AGENDA

The Planning and Zoning Commission and Board of Adjustment of the City of Sherman will hold a regular meeting Tuesday, July 22, 2025, at 5:00 PM in the Municipal Ballroom at 405 North Rusk Street to consider the following:

The request for approval of the Preliminary Plat of TDG Sherman has been reviewed by City Staff. The Preliminary Plat is to be considered Conditionally Approved Subject to Modifications indicated by this Staff Review Letter prior to Final Plat or Final Replat being submitted. Conditional Approval of this Preliminary Plat shall be effective for a period of twenty-four (24) months from the date of this letter.

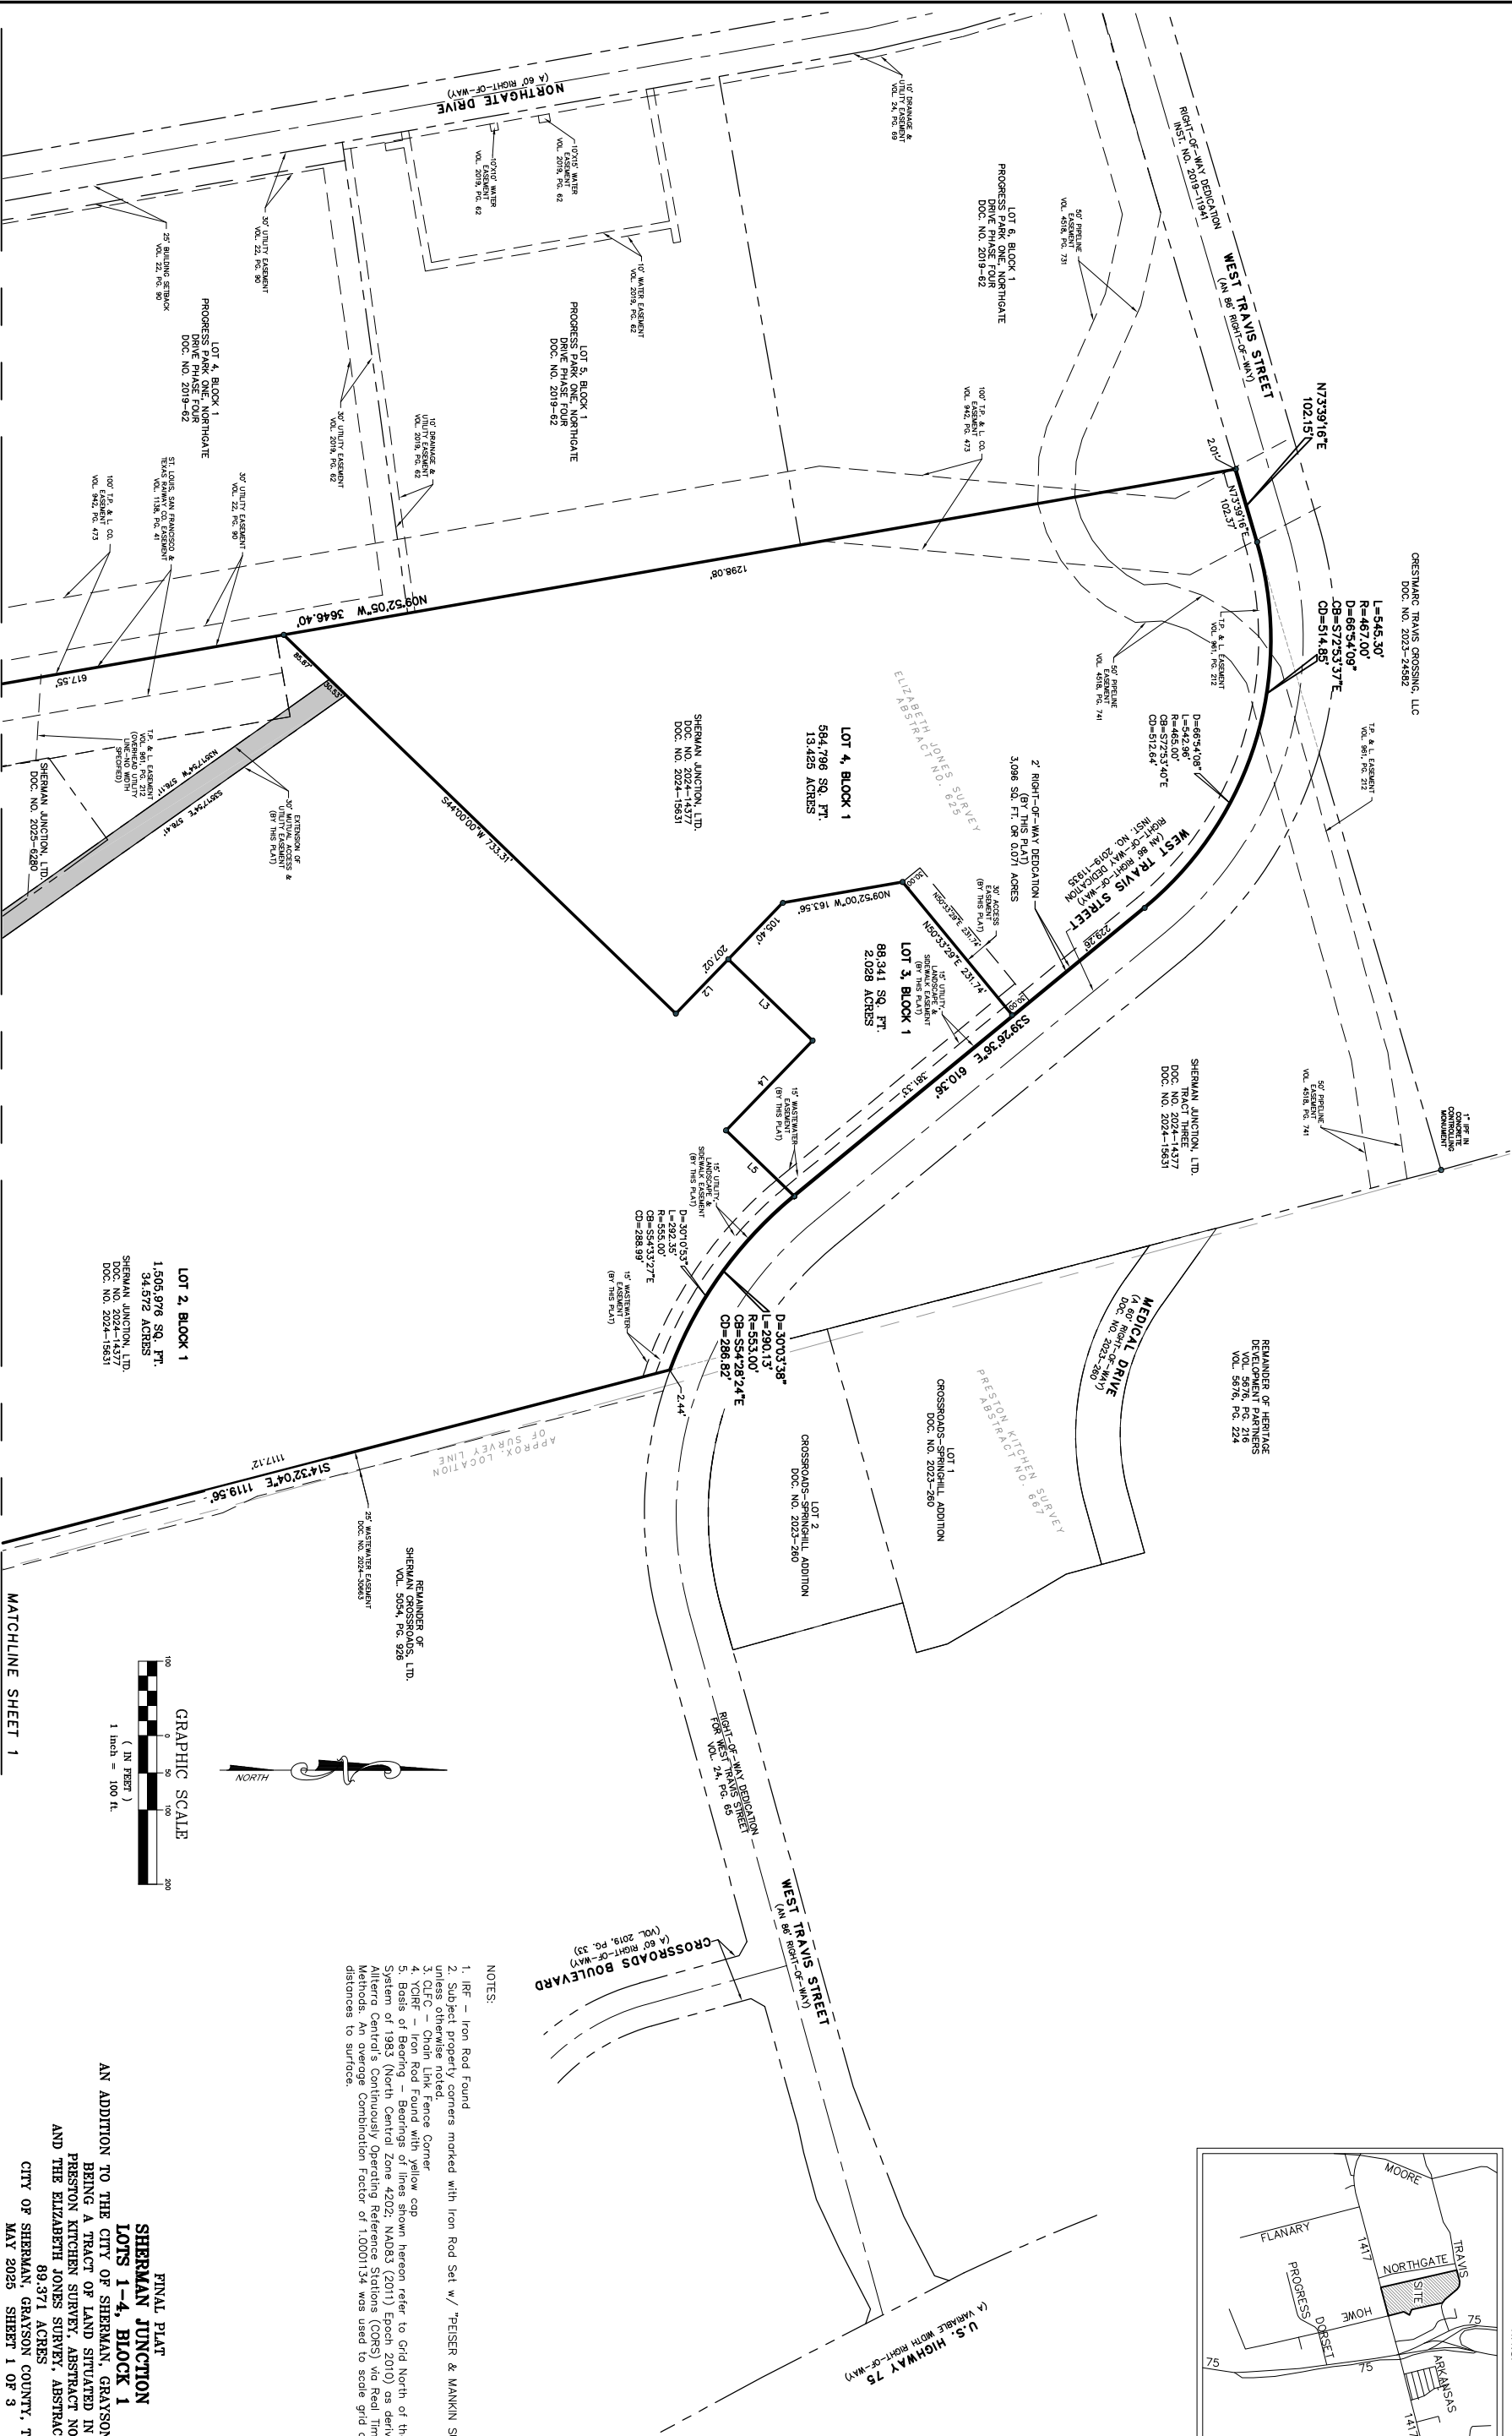
The request for approval of the Preliminary Plat of Sherman Junction has been reviewed by City Staff. The Preliminary Plat is to be considered Conditionally Approved Subject to Modifications indicated by this Staff Review Letter prior to Final Plat or Final Replat being submitted. Conditional Approval of this Preliminary Plat shall be effective for a period of twenty-four (24) months from the date of this letter.

1. Aston Drive right-of-way and easements shall be coordinated with Michael Carlisle, PE of Kimley Horn & Associates.
2. Dedicate Right of Way Dedication along FM 1417 in regard to Grayson County/City of Sherman Thoroughfare Plan. Drawing showing right of way dedication requirements has been uploaded to Self Service Portal Plan # 000026-2025-PLAT, 08 – 90% TxDOT ROW_12262024.pdf, for measurements. *Code of Ordinances Chapter 10.03.007(a); Engineering Design Standards Manual Table 2.1; Grayson County Subdivision Regulations 4.1.5*

3. Dedicate 65' of Right of Way for Aston Drive in regard to City of Sherman Thoroughfare Plan. *Code of Ordinances Chapter 10.03.007(a); Engineering Design Standards Manual Table 2.1*

9. Call along West Travis Street does not match metes and bounds description. Correct appropriately. *Code of Ordinances Chapter 10.02.002(e)(10); 10.02.003(f)(11)*

10. Call along Eastern boundary does not match metes and bounds description. Correct appropriately. *Code of Ordinances Chapter 10.02.002(e)(10); 10.02.003(f)(11)*

12. Remove "Current Zoning" from final plat.
13. Remove "Proposed Land Use" from final plat.
14. Verify Owner and Developer Addresses on plat drawing. Addresses are conflicting.

ENGINEERS, LAND PLANNERS AND LAND SURVEYORS		
DRAWN BY: CBW	CHECKED BY: WCT	RDE PROJECT No.: 3297-24
SCALE: 1"=100'	DATE: FEBRUARY, 2025	SHEET: 1 OF 3

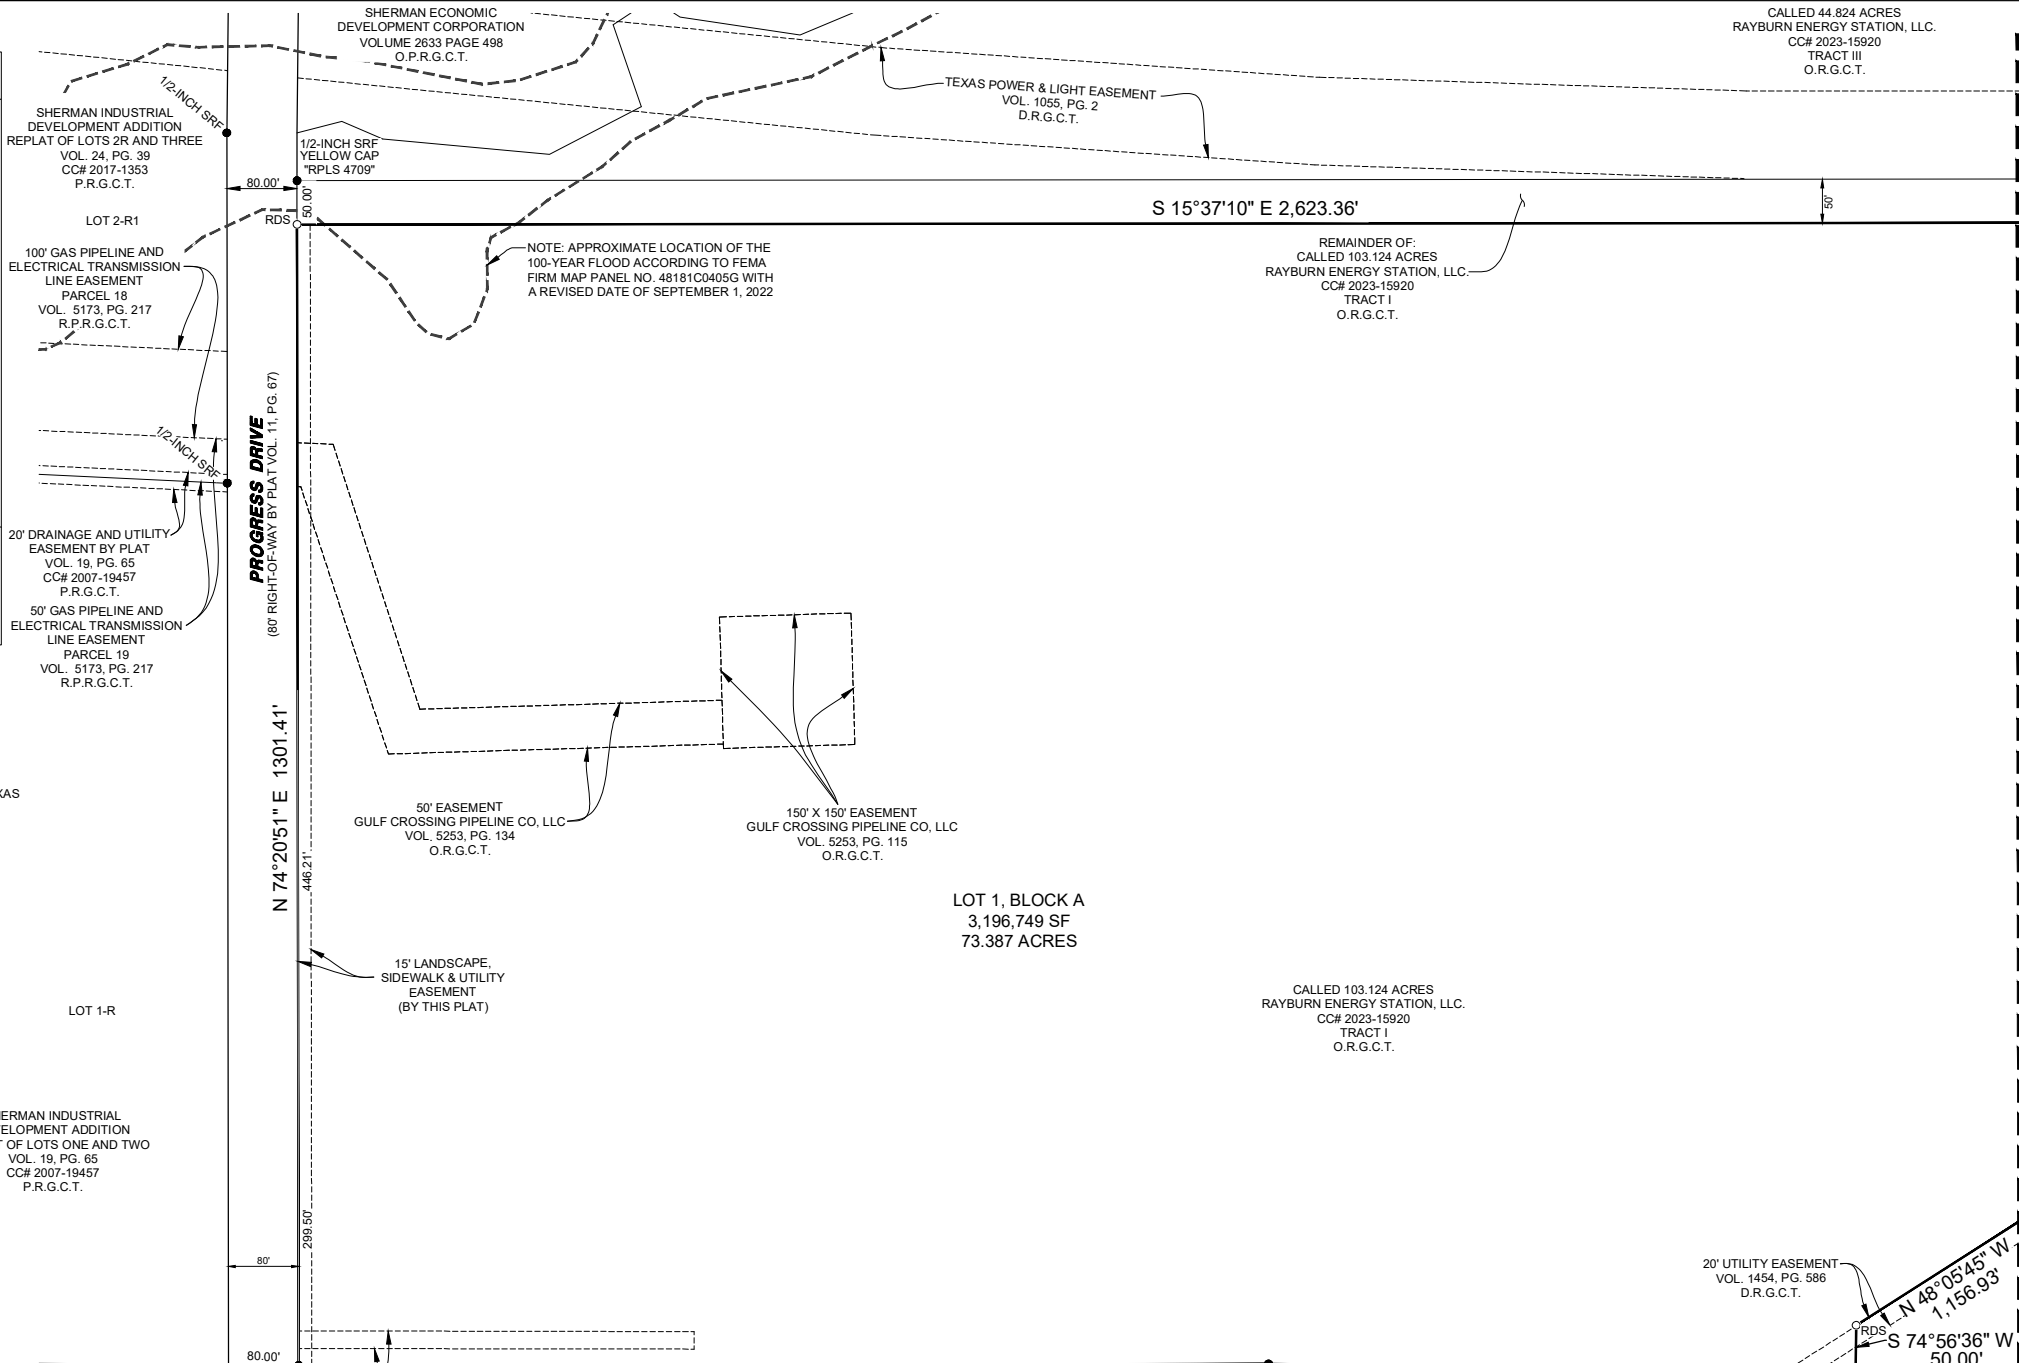
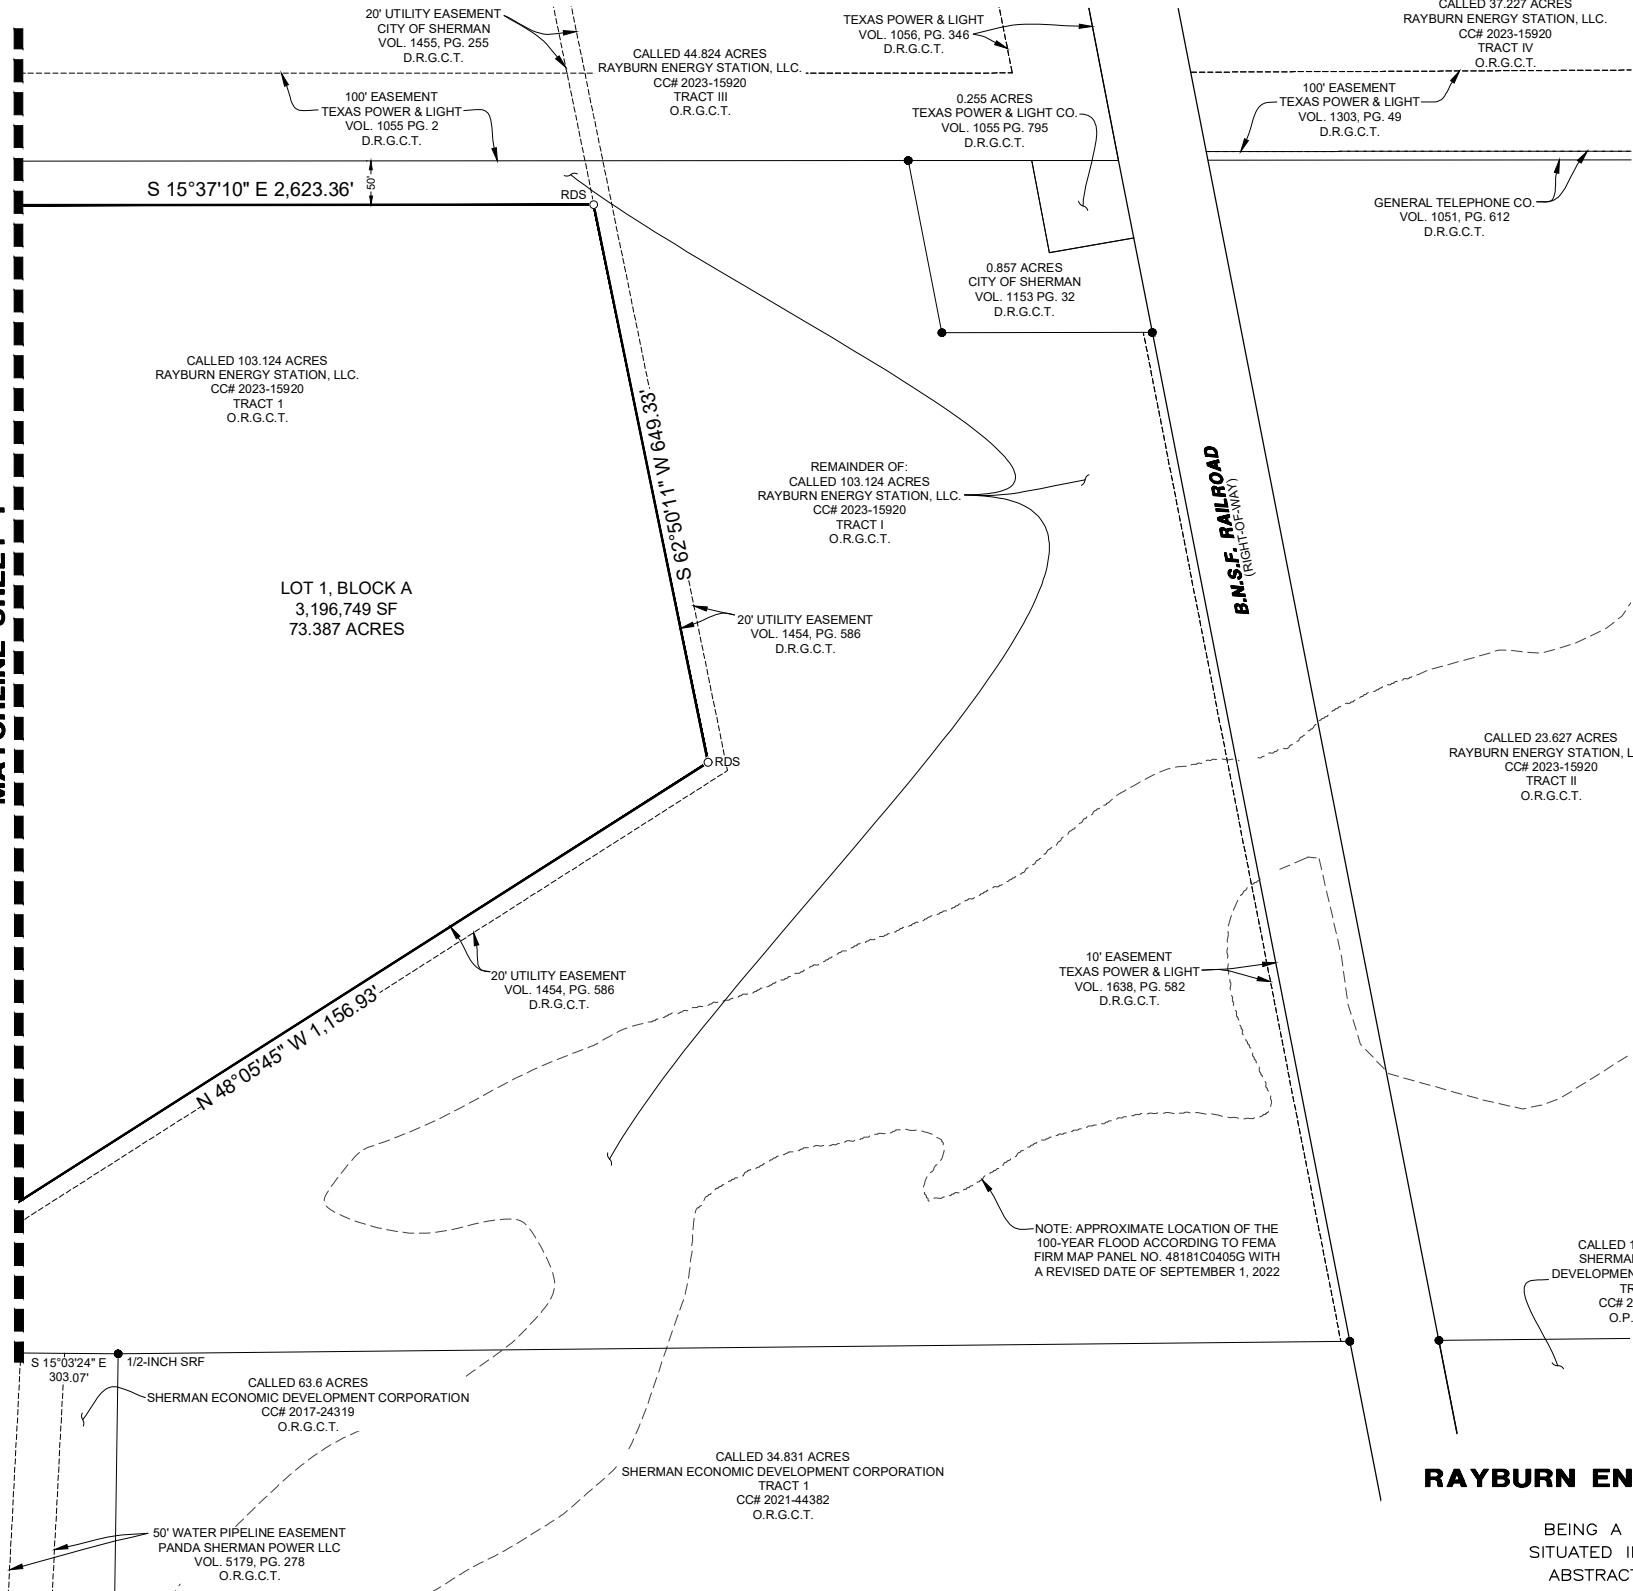
The request for approval of the Preliminary Plat of Rayburn Energy Station Addition has been reviewed by City Staff. The Preliminary Plat is to be considered Conditionally Approved Subject to Modifications indicated by this Staff Review Letter prior to Final Plat or Final Replat being submitted. Conditional Approval of this Preliminary Plat shall be effective for a period of twenty-four (24) months from the date of this letter.

1. Remove "FireLane" from 25' Access & Firelane Easement over existing pavement accessing property. Access Easement does not provide cross access to adjacent property. Coordinate with Engineering Department for need for Access Easement. *Code of Ordinances Chapter 10.03.003(h)(9); 10.03.007(a); Engineering Design Standards Manual 2.5(C)(6)*

2. Remove Variable Width Access, Firelane, and Utility Easement along western side of property. All internal utilities will be privately owned and maintained. Access Easement does not provide cross access to adjacent property. *Code of Ordinances Chapter 10.03.003(h)(9); 10.03.007(a); Engineering Design Standards Manual 2.5(C)(6)*
